RESOLUTION NO. 24623

A RESOLUTION APPROVING A PRELIMINARY PLANNED UNIT DEVELOPMENT SPECIAL EXCEPTIONS PERMIT FOR A PROPOSED PLANNED UNIT DEVELOPMENT, KNOWN AS THE STONE GATE PLANNED UNIT DEVELOPMENT, ON A TRACT OF LAND LOCATED AT 1615 DODSON AVENUE, MORE PARTICULARLY DESCRIBED HEREIN AND AS SHOWN ON THE MAP ATTACHED HERETO AND MADE A PART HEREOF BY REFERENCE, SUBJECT TO CERTAIN CONDITIONS.

P.U.D.: Stone Gate Planned Unit Development  
61 Dwelling Units

STATUS: Preliminary Planned Unit Development Plan

2005-0221

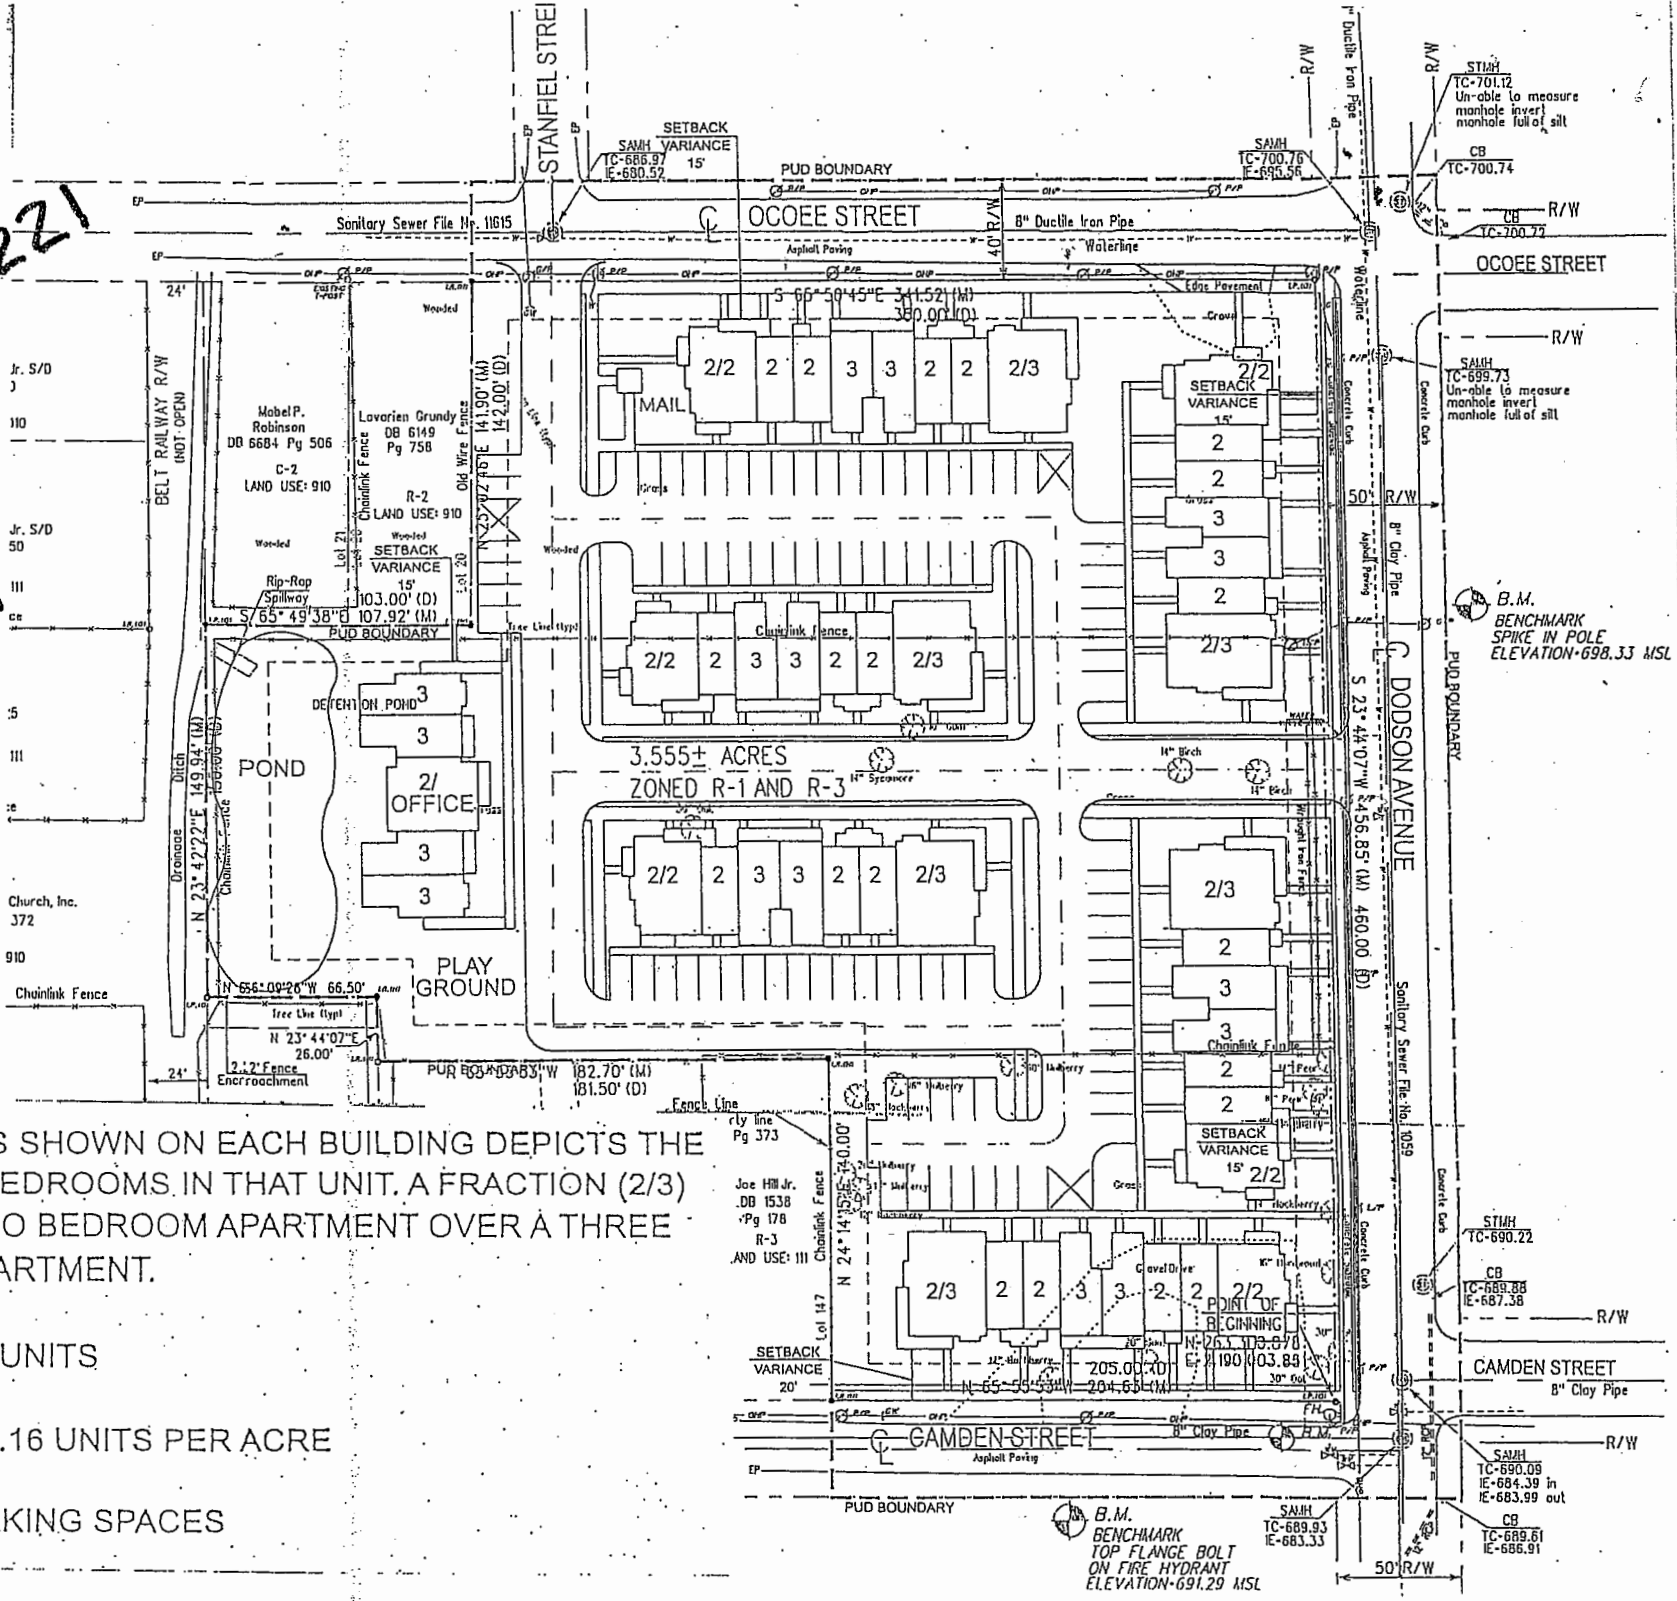
1. Because only one side of the streets is included in this P.U.D. plan, change the P.U.D. boundary to the center of Ocoee Street, Dodson Avenue and Camden Street. This is the same location shown on the attached 1" = 140' location map.
2. The proposed name, Stone Gate, is not acceptable because it has already been used. Consequently, select another name for this development and have it approved by the Regional Planning Agency staff.

3. Add a north arrow.
4. Article 5, Section 1703(U) of the Chattanooga Zoning Ordinance requires that multi-family dwellings with two or more bedrooms in a P.U.D. shall have at least 1.75 parking spaces per unit. Since all units are proposed to have two or more bedrooms, a minimum of 106 parking spaces is required. Consequently, either increase the number of parking spaces to 106 or obtain a variance of this requirement from the Chattanooga Board of Zoning Appeals or decrease the number of units to 53.

5. Article 5, Section 1204(3) of the Chattanooga Zoning Ordinance requires that no building can be located closer than 25' to the exterior property line of a P.U.D. Consequently, obtain a variance from the Chattanooga Board of Zoning Appeals for all buildings closer than 25' to the exterior property line or move proposed buildings to be 25' or more from exterior property lines.

6. Note the date any setback variance granted by the Chattanooga Board of Zoning Appeals.

1. Submit a hydrology report.
2. Submit details of the pond or drainage detention area.
3. If the area labeled "Pond" is not intended as a pond with standing water all of the time, change "Pond" to "Drainage Detention Area".
4. Without a hydrology report and drainage detention plan, there is not sufficient information to review this proposal.
5. Questions about Chattanooga Storm Water requirements should be directed to Mr. Lee Starnes at 643-5836.

1. One additional fire hydrant inside and near the center of the development is required.
2. Show the location of this fire hydrant.
